**Federal Highway  
Administration**

Subject: **ACTION:** New York State Department of Transportation's  
(NYSDOT) Proposed Bridge Railing Modifications

Date: November 8, 2000

STEEL BRIDGE RAILING  
(TWO-RAIL - BRUSH CURB)

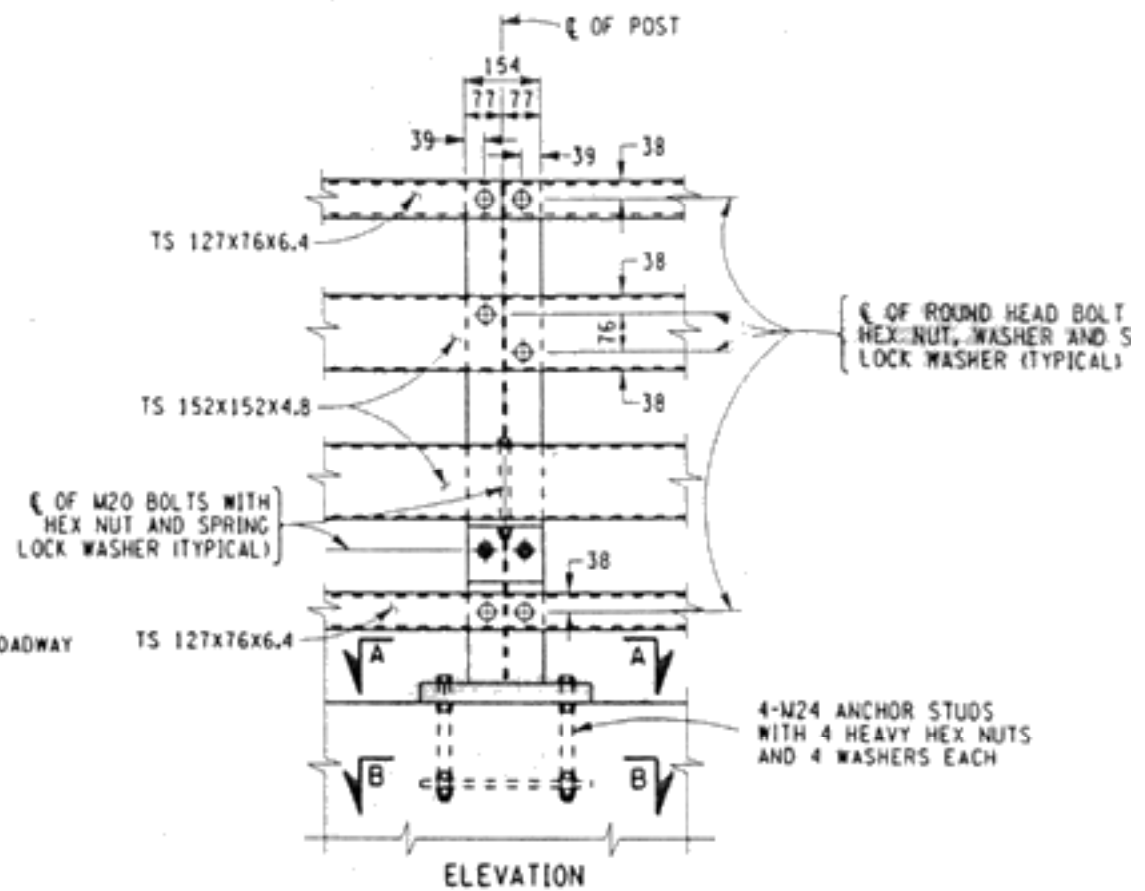
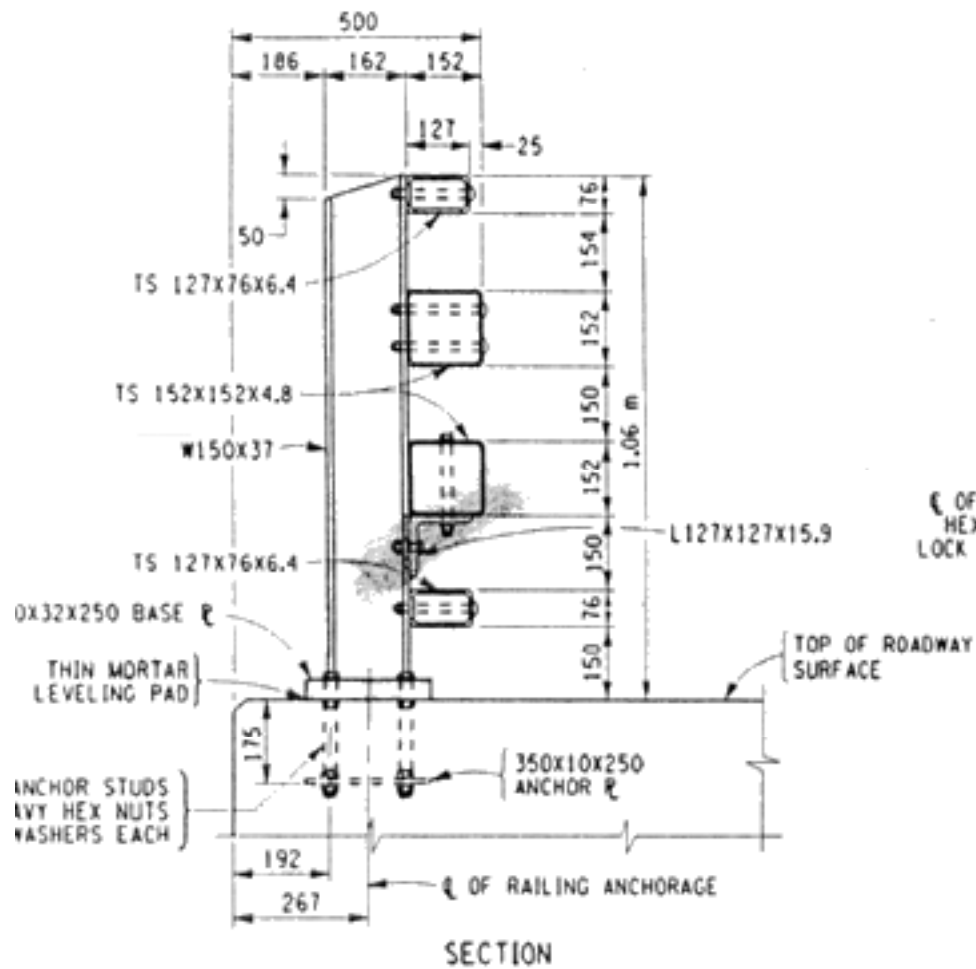
The two-rail design was tested without a curb. Tests with the 820-kg car and the 8000-kg single-unit truck met appropriate evaluation criteria. However, the test with the 2000-kg pickup truck resulted in vehicular snagging and passenger compartment intrusion considered likely by the researchers to result in serious injuries to vehicle occupants. When mounted directly on the deck, the clear opening from the deck to the bottom of the lower rail was 336 mm (approximately 13 inches), which allowed the wheel of the pickup to fold under the lower rail and impact a support post. This snagging resulted in the observed passenger compartment deformation and caused excessive damage to the bridge deck. The NYSDOT modification mounts this rail on a 150-mm (6-inch) curb, reducing the clear opening to 226 mm (approximately 9 inches), and increasing the overall height of the rail from 790 mm (31 inches) to 830 mm (32.6 inches). The resultant design is very similar to the New England Transportation Consortium's (NETC) two-rail curb-mounted design that has been successfully tested under NCHRP Report 350 guidelines. To minimize the bolt snagging noted in the NYSDOT test, the lower rail was mounted to the support posts with a steel shelf angle, thus eliminating the horizontal bolts through the rail which probably contributed to some of the snagging noted in the test. Thus, I agree that the modified curb-mounted design shown in Attachment 1 may be considered an NCHRP Report 350 TL-4 bridge rail.

STEEL BRIDGE RAILING  
(FOUR-RAIL - CURBLESS)

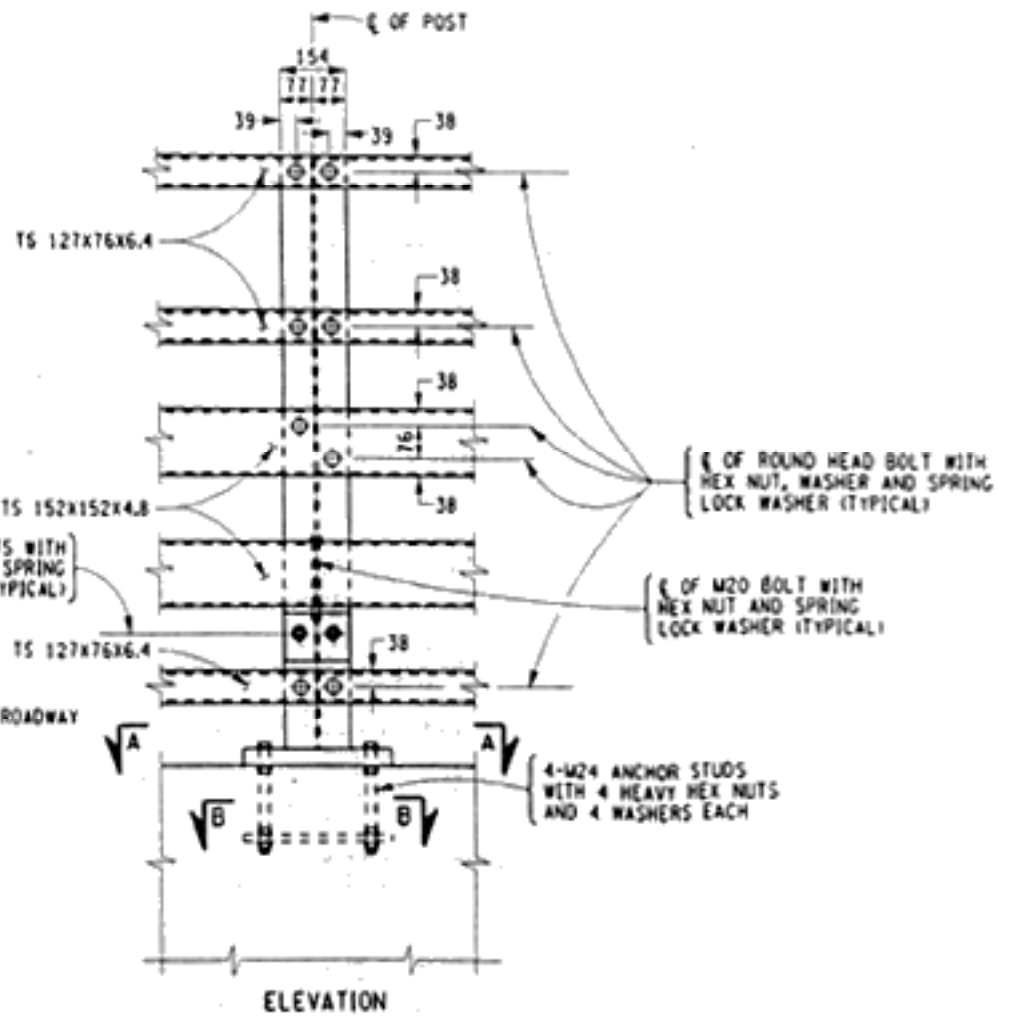
The deck-mounted four-rail design shown as Attachment 2 successfully met all evaluation criteria for a TL-4 design when tested at TTI. The lower 152 mm x 152 mm x 4.8 mm rail-to-post attachment was modified by using a shelf angle as noted above for the two-rail

design. Based on tests of similar bridge railing designs mounted behind a sidewalk with a curb height of 200 mm (8 inches) or less, I agree that the NYSDOT four-rail design remains acceptable as a TL-4 bridge rail when used behind a 1.525-m (5-foot) wide or wider sidewalk having a curb height of 200 mm (8 inches) or less.

STEEL BRIDGE RAILING  
(FIVE-RAIL - CURBLESS)

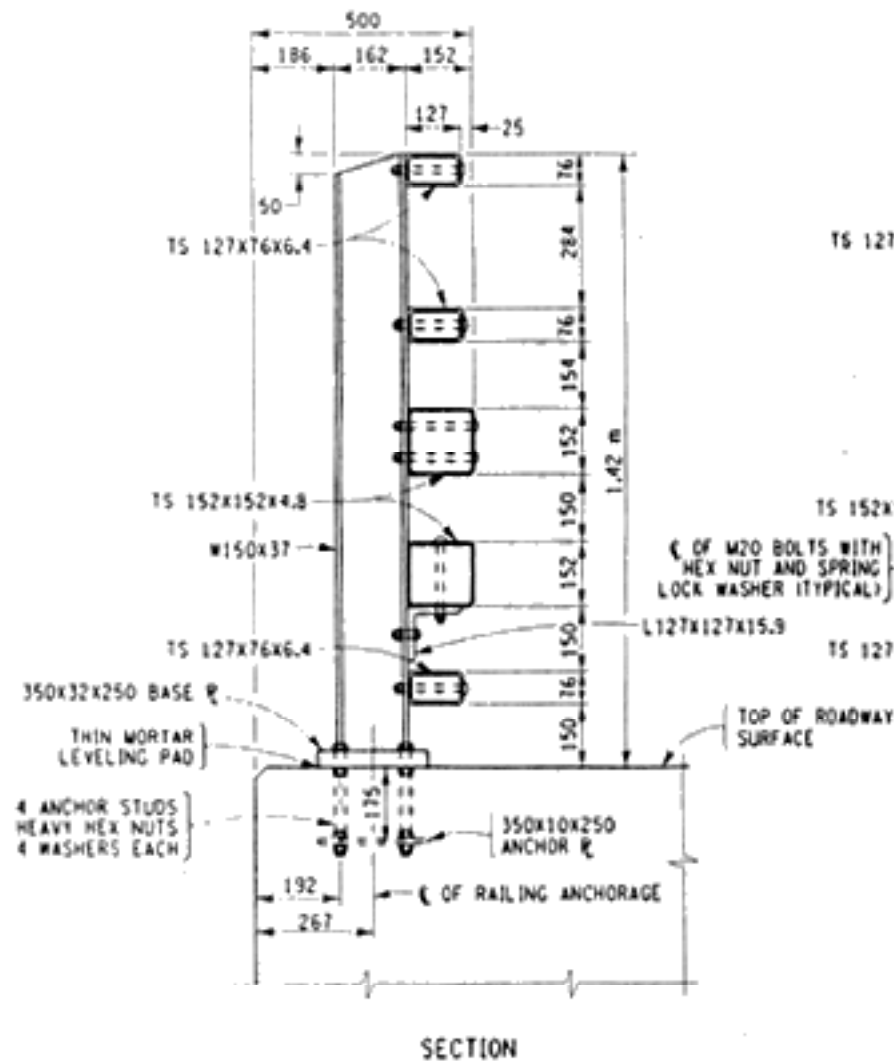
The five-rail design shown as Attachment 3 is identical to the four rail design except for the extra height and additional rail. A review of the crash tests for the four rail design showed that there was no significant vehicle overhang of the top rail. Thus, the additional height does not appear to create a snagging problem with the pickup truck and would likely reduce the roll angle observed with the single-unit truck. Consequently, this design may also be considered a TL-4 railing.
